Responses to Open Items
Related to the License Amendment Request for the
Upgrade of the Instrumentation and Control System
for the
Armed Forces Radiobiology Research Institute
TRIGA Reactor

7 January 2022

The following are responses to open items from the on-going audit in support of the Digital Instrumentation and Control System Upgrade for the AFRRI TRIGA Reactor (EPID L-2020-NFA-0012).

Figure 3-1 – Pulse Mode Functional Block Diagram for the Old AFRRI Control Console.

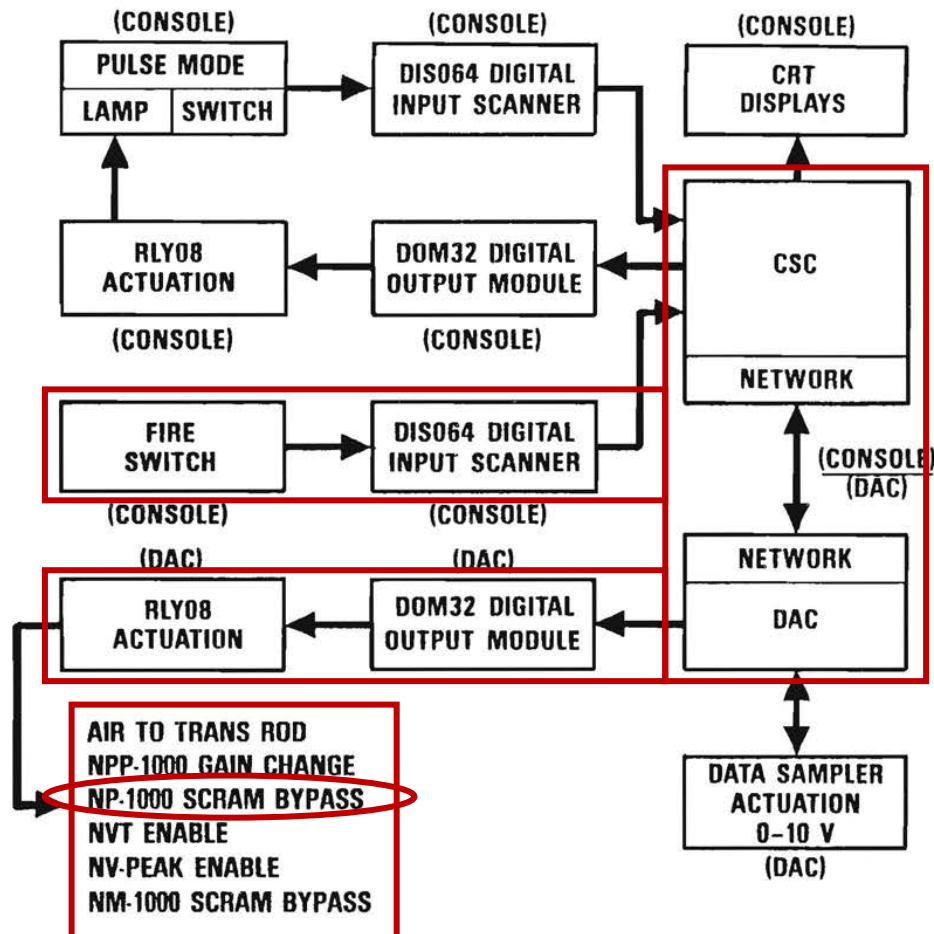
3. During a pulsing operation, an additional Inhibited field will be shown for the NLW and NMP channels and an additional Bypassed field will be shown for the NP channel in the control console. Describe what signals generate the Inhibited field signal?

The control console has always performed the bypass for the NP-1000 overpower scram during Pulse Mode operation. This software control has been maintained in the new control system. Refer to Figure 3-1 – Pulse Mode Functional Block Diagram for the Old AFRRI Control Console which is from previous control console Operation and Maintenance Manual E117-1006, Figure 3-11.

These signals are generated by the control console computer. The sequence of events are (refer to Section 2.19 Pulse Mode of SAT 1 (page 67):

- The computer sends a signal to the to the NP (bypass the overpower scram), the NLW (disconnect the electrometer) and NMP (disconnect the electrometer); signal is sent to the NPP for gain adjustment during pulse.
- The console display will show the NP bypassed, NMP and NLW inhibited fields.
- The pulse occurs.
- The pulse timer scram occurs.
- The units automatically drop out of bypass/inhibited; NPP gain reverted.

Figure 7-1 – Ranges of Operation for the NMP-1000

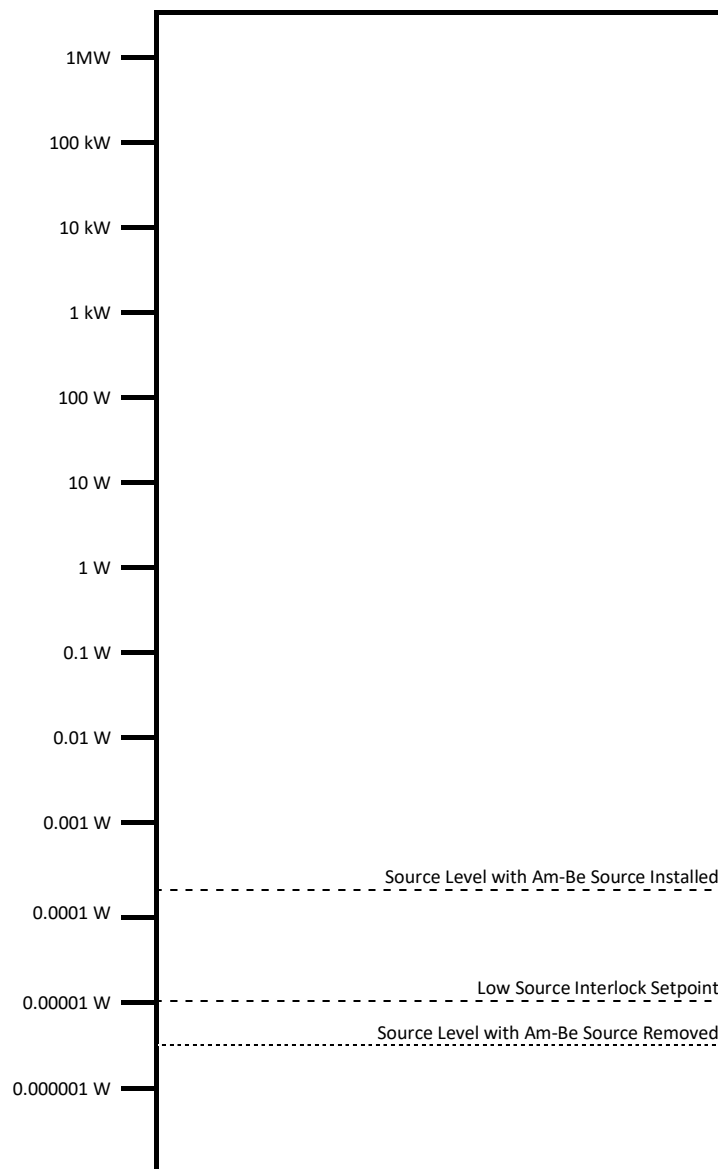
7. **In the LAR, AFRRI proposed a Technical Specification change to replace the setpoint for the rod withdrawal interlock for the NMP-1000. The modification would change the setpoint for the power level from <0.5 cps. to <1x10⁻⁵ watts. Explain whether these setpoints are equivalent, and provide the calculation that shows this conversion.**

The NMP-1000 channel provides the Low Source Interlock. The NMP-1000 uses a compensated ion chamber, and as such, outputs a current and is designed to display in watts and not counts per second (cps), therefore the interlock setpoint needs to be specified in watts.

The design function of the low source interlock is to only permit rod withdrawal when there are sufficient neutrons to provide proper instrument response for bringing the reactor critical under controlled conditions. Therefore, it is only necessary to verify that the channel is capable of performing this design function. This is accomplished by using a neutron source to ensure that the channel is responding to neutrons and not just gammas. The neutron source used at AFRRI is a 3 curie (Ci) americium-beryllium (Am-Be), cylindrical-shaped, double encapsulated source. The source is located in the core, and remains there during operation, but can be removed for training, maintenance, and to verify the functionality of the source interlock.

During the functionality test, the source is removed from its normal in core location and the power monitoring instrument, NMP-1000, is allowed to drop below the interlock setpoint which trips the rod withdraw interlock and prohibits the withdrawal of control rods. This test ensures that the interlock is set properly.

From Figure 7-1, it is shown that a setpoint of 1×10^{-5} watts is well above the level when the source is removed which provides assurance that channel is operating correctly by detecting sufficient source neutron prior to startup. Therefore, it is concluded that the proposed change to Table 3 of TS 3.2.2 for the source range interlock will continue to perform the design function required by this channel.

Figure 5-2 – Core Dolly Limit Switch Diagram

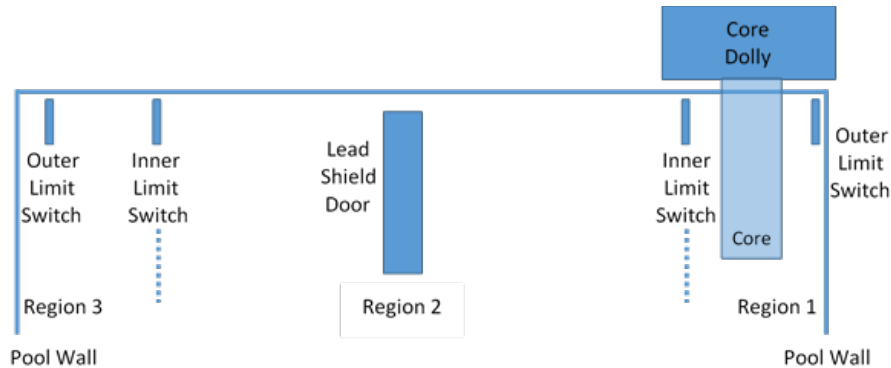
9. **Provide additional information to supplement Section 2.3 of LAR, Rev. 1, regarding the operation of the dolly switch.**

For each region there are two limit switches that will stop core dolly movement - the inner and outer limit switches. Refer to Figure 5-2 for a diagram of the switches. The outer limit switch stops the core dolly when it reaches the far end of the travel to prevent contacting the pool liner. The outer switches cannot be overridden. To prevent contact with the lead shield doors, the inner limit switch stops the core dolly from further movement if the lead shield doors are not fully opened.

For example, take the scenario of the operator moving the core dolly toward region 3 with the lead door closed. Once the core dolly comes off of the inner limit switch (switch is now open) the core dolly will stop and further movement of the core dolly is prohibited, this includes movement back toward region 1. Originally, the only way to recover from this scenario was to manually actuate the switch. This was accomplished by inserting a finger through a cutout in the core dolly rail and pushing down on the lever arm of the switch. Refer to Figure 5-3 below.
